UNITED STATES PATENT AND TRADEMARK OFFICE

APPLICATION NO.	FILING DATE	FIRST NAMED INVENTOR	ATTORNEY DOCKET NO.	CONFIRMATION NO.
10/699,152	10/31/2003	Flabio Cavalheiro		1479
7590 Stephen E. Feldman Suite 701 12 East 41st. New York, NY 10017	01/19/2007		EXAMINER KARLS, SHAY LYNN	
			ART UNIT 1744	PAPER NUMBER
SHORTENED STATUTORY PERIOD OF RESPONSE	MAIL DATE	DELIVERY MODE		
3 MONTHS	01/19/2007	PAPER

DETAILED ACTION

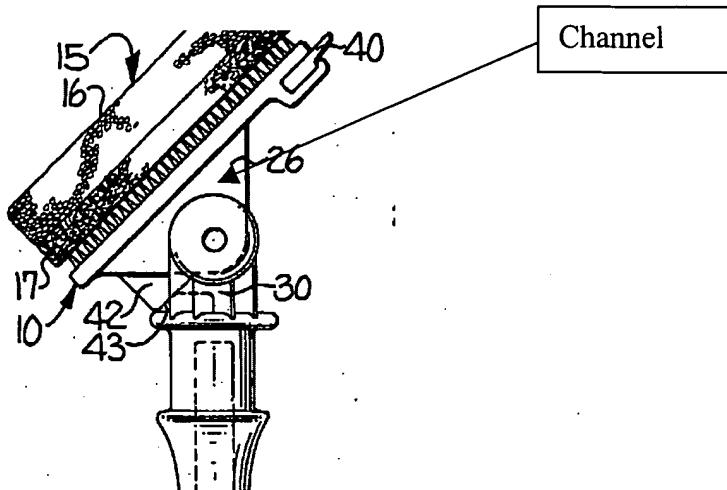
Graham teaches a cleaning device comprising a cleaning member (figure 1, element 15) with a first surface having a scouring surface of loop material (figure 1, element 17) (claims 1, 7 and 8) and a second surface comprising a sponge (figure 1, element 16) (claim 10). There is a base plate (figure 1, element 10) having a plurality of projections (figure 1, element 20) arranged in rows and columns for gripping the first surface of the cleaning member (claims 1, 6). The projections each have a top segment having opposing ends (figure 6, element 21) and an intermediate section separating the top segment from the base plate by a predefined distance (claim 1). The opposing ends of the projections each have free ends, which terminate at substantially a point, and therefore the opposing ends have a cross section that is thicker at the connection of said ends to the top segment than at said free ends (figure 7) (claims 2, 3, 4). The intermediate section having bottom end defined by the connection of the intermediate section to the base plate and a top end defined by the connection of the intermediate section to the top segment, wherein the cross section is thicker at the bottom end than at the top end (figures 6 and 7) (claim 3). The distance between the end of each free end is *substantially* the same as the distance between the top end and the bottom end of the intermediate segment (figure 7) (claim 5). The base plate comprises an ergonomic, contoured handle member (figure 1, element 25) (claim 1) including a grasping means that is curved throughout and configured to closely conform to the curvature of the inside of a user's hand (claim 1) and the grasping means is

removable from the base plate (figure 5) (claim 12). The handle further includes a bottom surface (portion of 30 that is located closest to the base plate) and an outermost circumference (widest portion of handle). There is a column (26) for connecting the base plate to the handle. The column has a diameter and an outer surface. The handle has a channel formed between a bottom surface of the handle, the outermost circumference of the handle, the column and the base plate. The channel is configured in such a manner as to accept at least part of a user's finger when the handle is grasped (see figure below) (claim 1). The column is capable of being disengaged for removing the handle from the base plate (figure 5 shows it disengaged) (claim 1).

Graham teaches all the essential elements of the claimed invention however fails to teach that the projection is T-shaped with the top segment having a substantially straight upper surface (claim 1). Graham also fails to teach that the channel has a depth defined by the outermost circumference of the handle and the outer edge of the column, the depth being at least equal to the diameter of the column (claim 1).

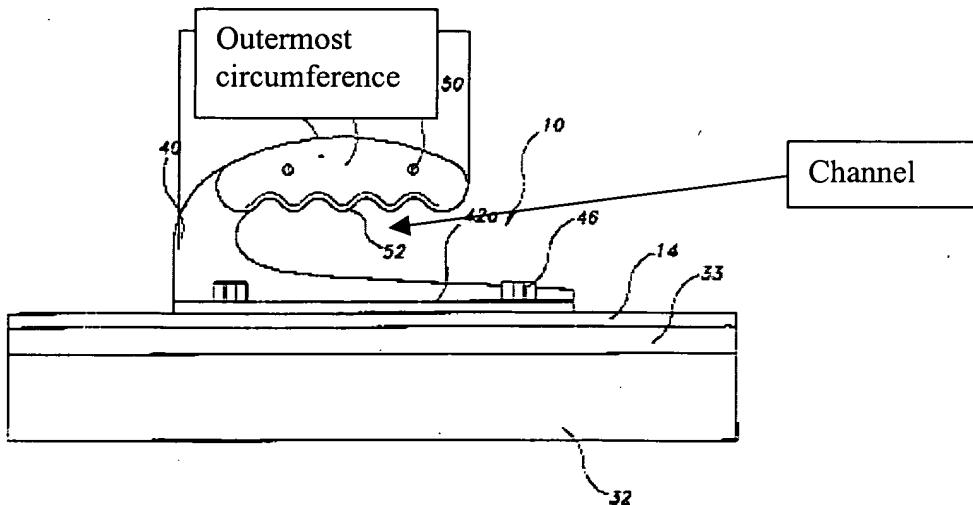
Hintz teaches a cleaning device comprising a cleaning member (figure 3, element 32) with a first surface having scouring surface of loops (figure 3, element 33) (claims 1, 7, 8) and a second surface comprising a sponge (figure 3, element 32) (claim 10). There is a base plate (figure 3, element 14) having a plurality of projections (figure 3, element 34) arranged in rows and columns for gripping the first surface of the cleaning member (row and columns can be formed from any formation of projections—not limited to linear) (claims 1, 6). The projections each have a top segment having opposing ends and an intermediate section separating the top segment from the base plate by a predefined distance (common hook and loop material is used; col. 3, lines 37-42) (claim 1). The base plate comprises an ergonomic, contoured handle member (figure 2, element 40) (claim 1) including a grasping means that is curved throughout and

configured to closely conform to the curvature of the inside of a user's hand (claim 1) and the grasping means is removable from the base plate (figure 2, element 46) (claim 12). The handle further includes a bottom surface (portion of 48 with finger ridges) and an outermost circumference (distance around the handle longitudinally). There is a column (40) for connecting the base plate to the handle. The column has a diameter and an outer surface. The handle has a channel formed between a bottom surface of the handle, the outermost circumference of the handle, the column and the base plate. The channel is configured in such a manner as to accept at least part of a user's finger when the handle is grasped (see figure below) (claim 1). The column is capable of being disengaged for removing the handle from the base plate (figure 2) (claim 1).

Hintz teaches all the essential elements of the claimed invention however fails to teach that exact details of the projections. The reference does not teach that the projection is T-shaped with the top segment having a substantially straight upper surface (claim 1) and the opposing ends of the projections have a free end, and the opposing ends have a cross section that is thicker at the connection of the ends to the top segment than at the free ends (claim 2). Additionally, Hintz fails to teach that the intermediate section of projections have a bottom end defined by the connection of the intermediate section to the base plate and a top end defined by the connection of the intermediate section to the top segment, wherein the intermediate section has a cross section that is thicker at the bottom end than at a top end (claim 3). Hintz also fails to teach the opposing ends terminate at substantially a point (claim 4) and that the distance between the top end and the bottom end of the intermediate segment are substantially the same (claim 5). Additionally, Hintz also fails to teach that the channel has a depth defined by the outermost

circumference of the handle and the outer edge of the column, the depth being at least equal to the diameter of the column (claim 1).

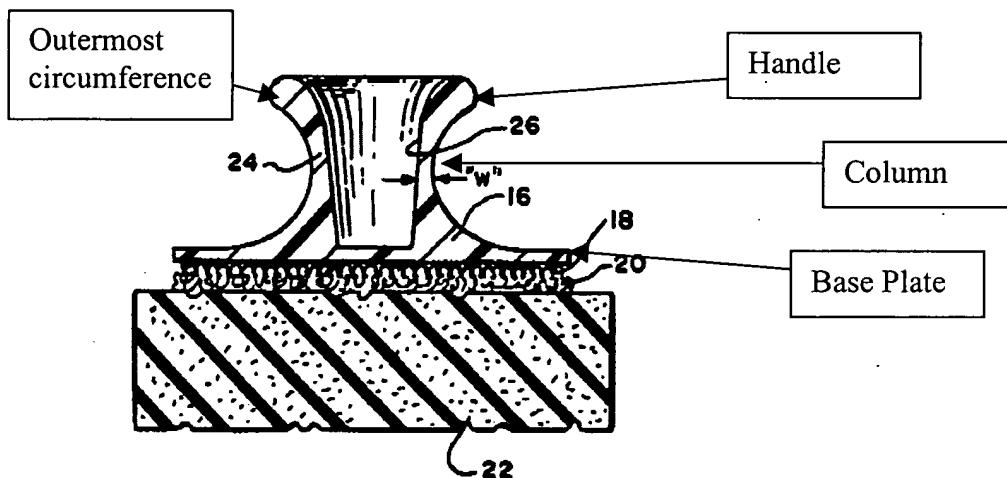
Fay teaches a cleaning device comprising a handle (11) and base plate (1). There is a cleaning member (15) attached to the base plate. The handle comprises a channel (13) between the bottom surface of the handle and the base plate. There is a column (12) connecting the handle and the base member. The column allows the handle to be removed from the base plate.
